Testimony – City Council Land Use Committee
Riverside Center Proposal

RIVERSIDE CENTER

An Alternative Plan

Coalition For a Livable West Side

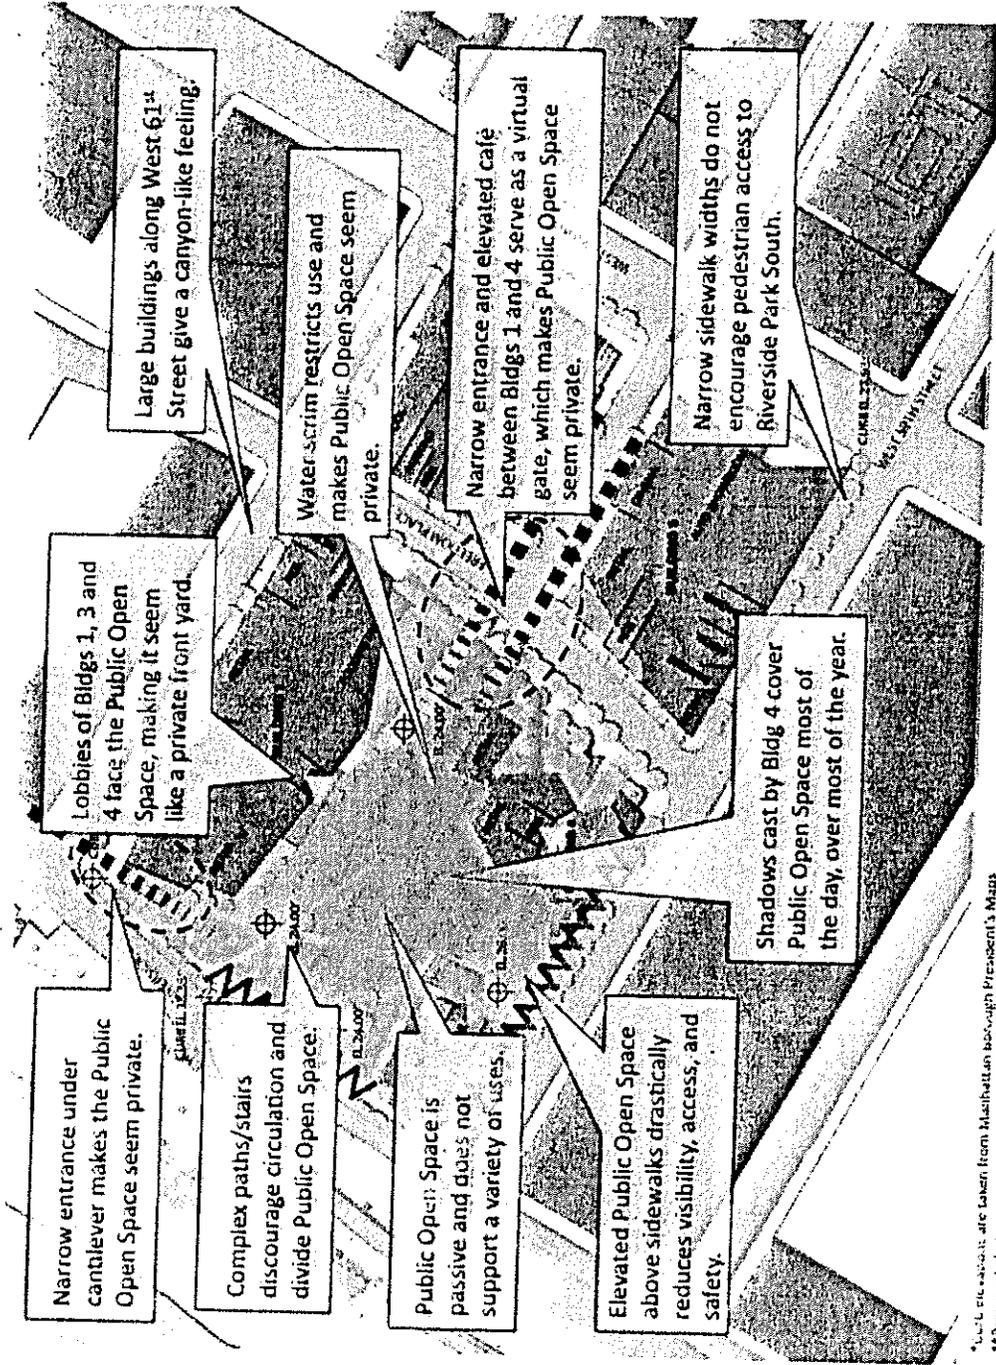
MCB7 recommends modifying the footprint of Building 5 to accommodate the "straightening" of Freedom Place South to expand Public Open Space, further reduce density, reinforce the city grid, and provide visual perspectives of the historic powerhouse.

MCB7 recommends eliminating the private driveway that serves Building 3 to expand Public Open Space and reinforce the city grid.

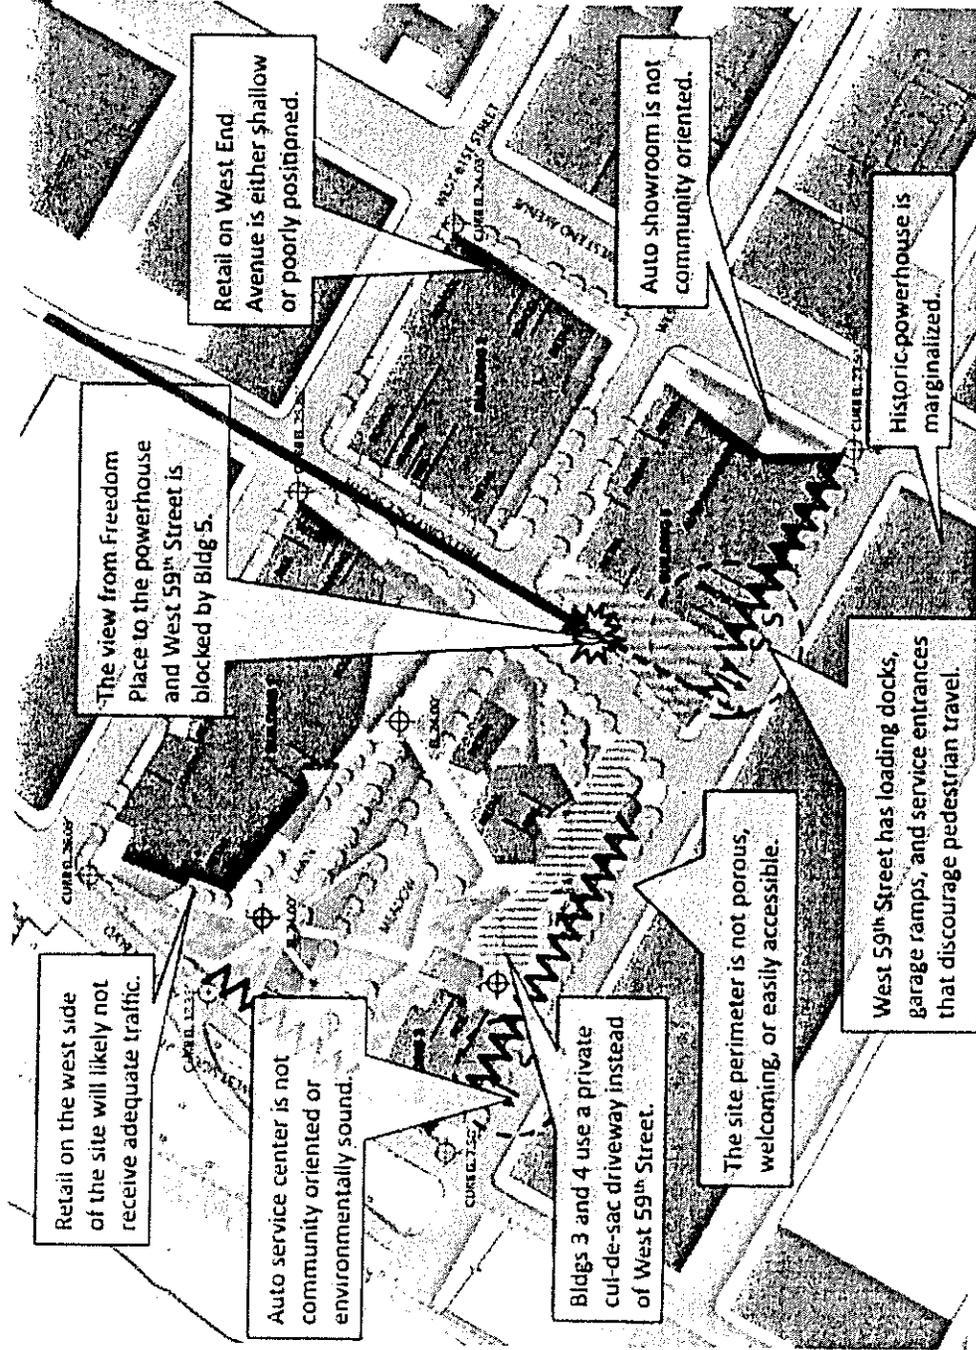
The DSEIS recommends that West 59th Street become a westbound street to allow drivers to access the site from the east. The 1992 Restrictive Declaration required that West 61st Street become a westbound street, but NYC Department of Transportation (NYC DOT) is not considering this.

Additionally, NYC DOT has decided to install a pedestrian refuge island at West 61st Street and West End Avenue and prohibit left turns into Riverside Center from northbound West End Avenue. This means the only access onto West 61st Street between West End Avenue and Riverside Boulevard will be from the north. Given that West 61st Street will be a primary roadway into the site, and the 8-year construction plan calls for trucks to be allowed to make this left turn, MCB7 believes the island should be moved to West 62nd Street.
